ADDENDUM #2

DATE: March 12th, 2018

RE: South Airport Rd – US 31 to Veterans Dr Project (#18E004)

SOUTH AIRPORT ROAD, STA 119+00 TO STA 128+00
DATE \$DATE\$ TOWNSHIP GARFIELD SHEET NO. 19
WEST OF US-31 TO VETERANS DR

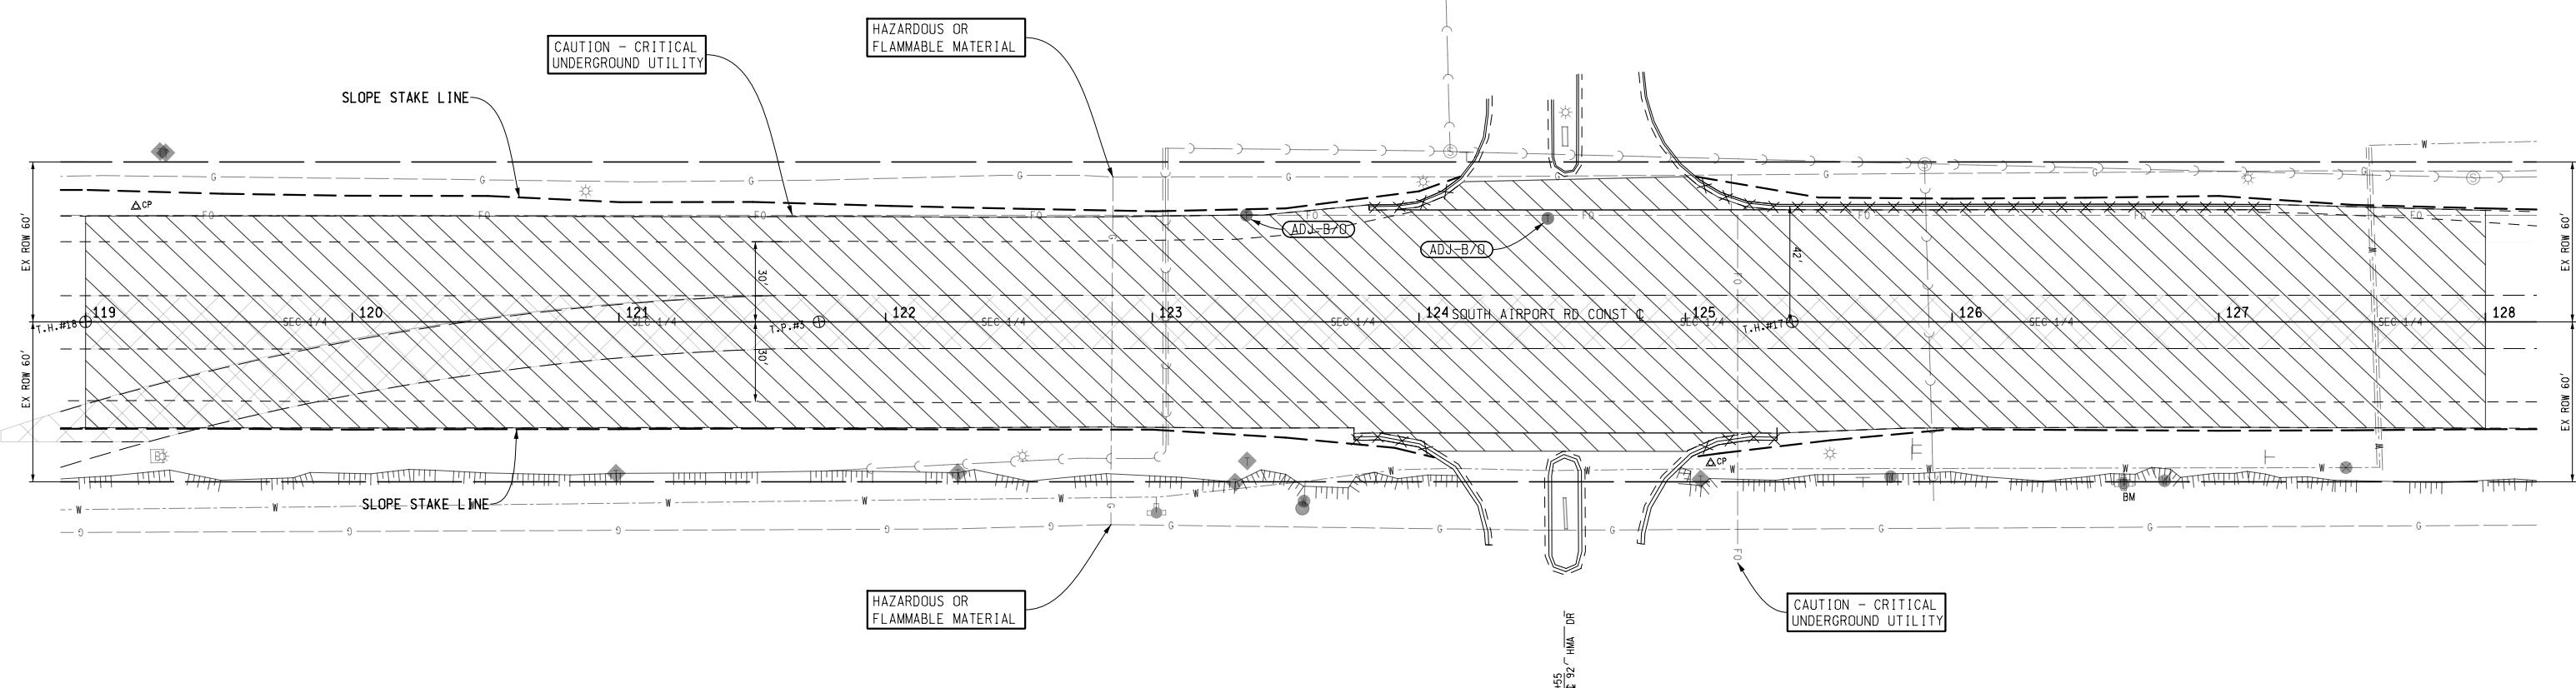
Sheet 19: Pav’t Removal total has been updated to include added area easterly of Sta 119+00.

REMOVAL QUANTITIES THIS SHEET
8105 Syd HMA Surface, Rem
9.0 Sta Roadway Grading, Type 2
2044 Syd Pav. Rem ADDENDUM 3-12-18
2371 Syd Pav. Rem ADDENDUM 3-12-18
